ADDENDUM NO. 1

PROJECT: REGIONAL HEADQUARTERS ADMINISTRATION BLDG.
UPSTARIS REMODEL

FWP PROJECT #: 7079146

DATE: June 14, 2012

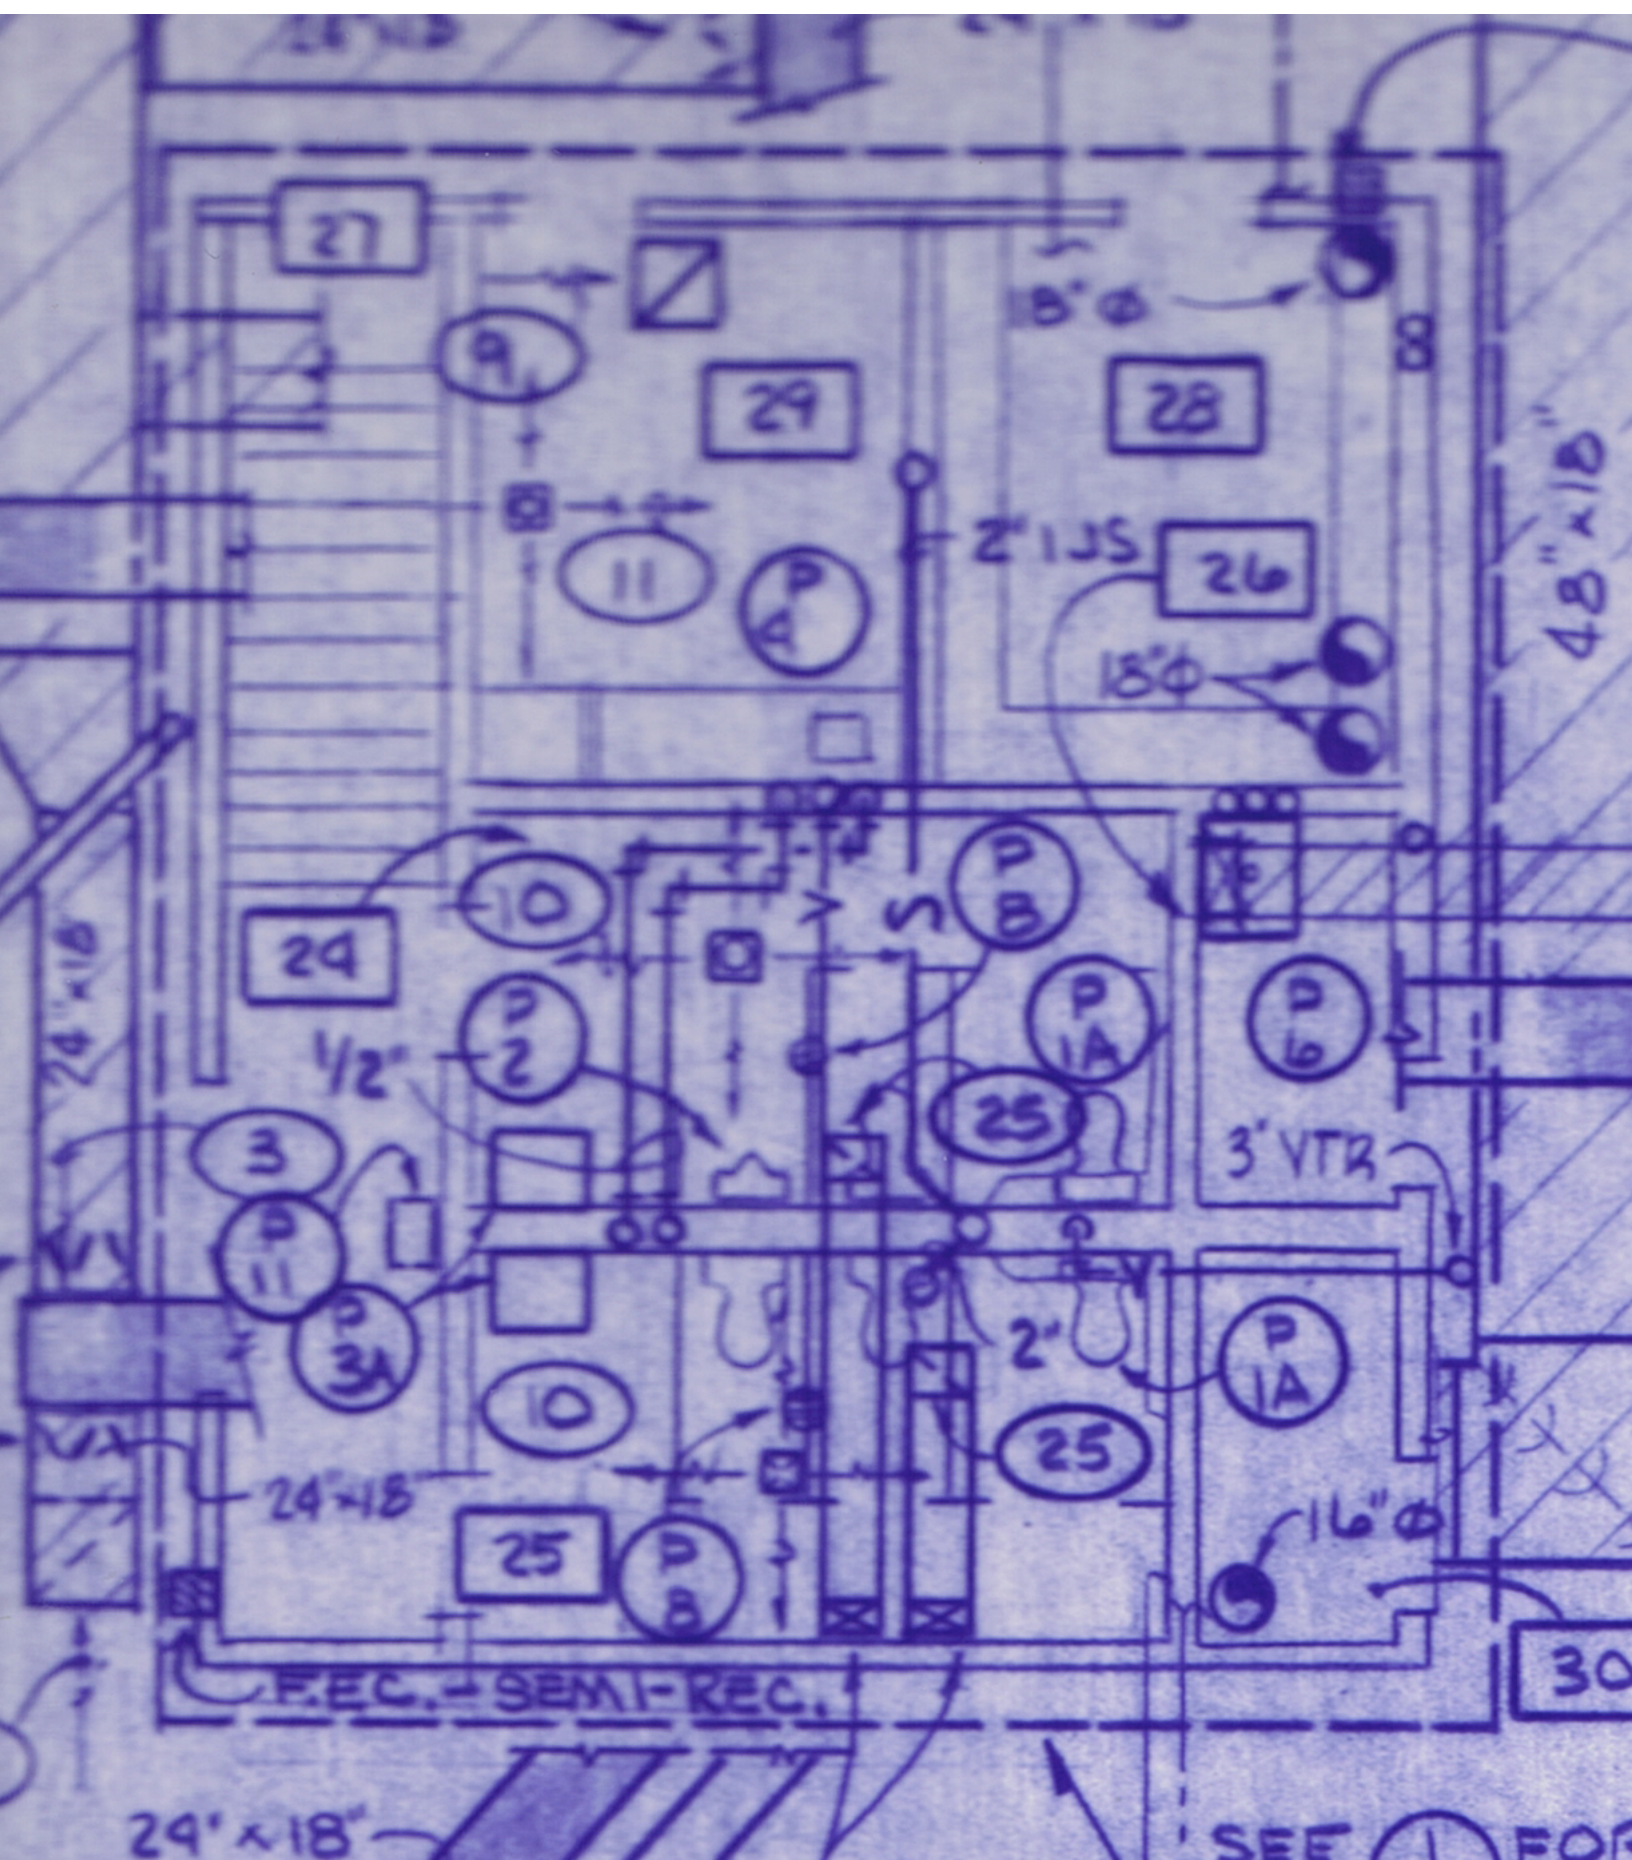
- 8) Clarification – Hardware, acceptable substitute: Sargent 10 line locksets, Sargent 281 closers and McKinney hinges.
- 9) Clarification – Existing conditions, see attached plan and legend for mechanical conditions from original construction documents.
- 1) Modification – Hardware, acceptable substitute, Sargent 10 line locksets, Sargent 281 closers, and McKinney hinges.
- 2) Modification – Windows, acceptable substitute, Jeld-Wen aluminum clad wood windows, species to match existing adjacent.
